PG&E Letter DCL-17-009

Docket No. 50-275, OL-DPR-80
Docket No. 50-323, OL-DPR-82
Diablo Canyon Power Plant Units 1 and 2
Appeal of Final Significance Determination Process Finding; EA-16-168

Figure 1 – Event Timeline

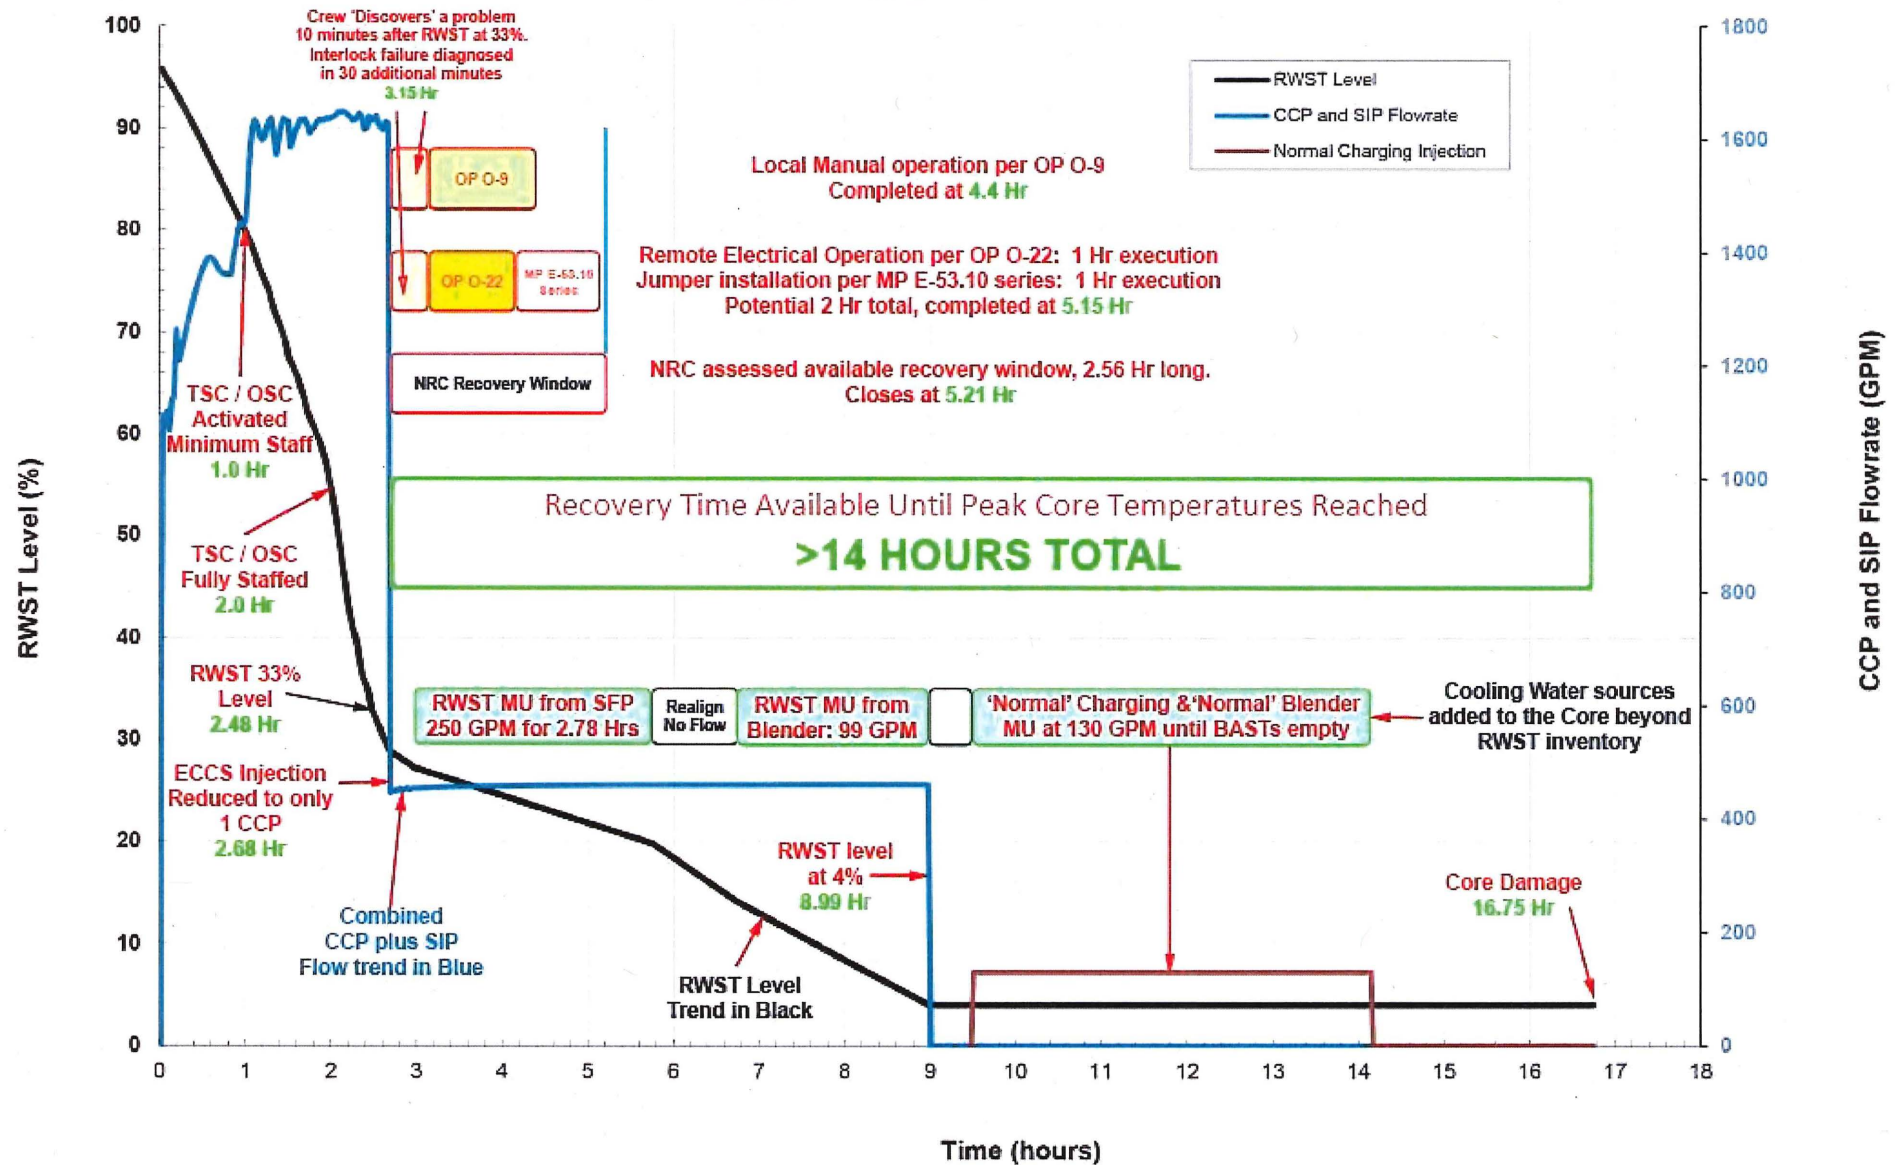
- Control Room-directed EOP actions that extend the time available for recovery of Valve SI-2-8982B and TSC-directed local recovery actions proceed in parallel (not sequentially).
- Two TSC-directed local recovery actions (electrical and mechanical recovery) proceed in parallel (not sequentially)³ using separate response teams.
- Consideration of Control Room-directed actions in parallel with TSC-directed local recovery actions results in approximately 14 hours available for recovery of Valve SI-2-8982B.

Reference 5 demonstrates that, at 6.51 hours after RWST reaches the 33 percent level, the RWST would be at the 4 percent level (Table 1). At 6.51 hours after RWST reaches 33 percent, operators start step 30 of EOP ECA-1.1.

PG&E modeled 30 minutes of no makeup to the RCS while operators perform the alignments directed by EOP ECA-1.1, Appendix W. At 7.01 hours after reaching 33 percent level, makeup to the RCS from the VCT, as supplied by the blender, is initiated at the maximum makeup flow of 130 gallons per minute (gpm). This makeup rate is not sufficient to match the decay heat load required flow for continued cooling, but does significantly extend the time until core damage. The procedurally required action to implement EOP ECA-1.1, Appendix W, following RWST level reaching 4 percent significantly extends the time available for recovery actions.
